PEERLESS FARMS

PRELIMINARY PLAN

16975 FALCON HIGHWAY, PEYTON, CO

COVER SHEET
SHEET 1 OF 3

FLOODPLAIN NOTES:

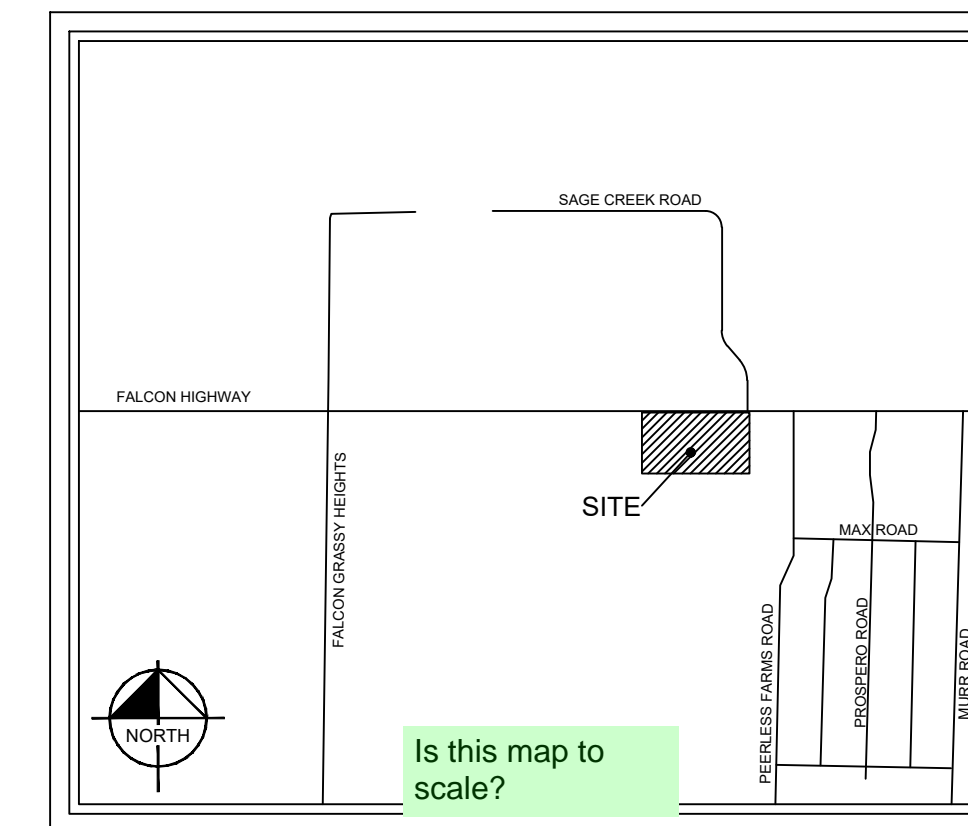
Property is within a floodplain.
Please revise note
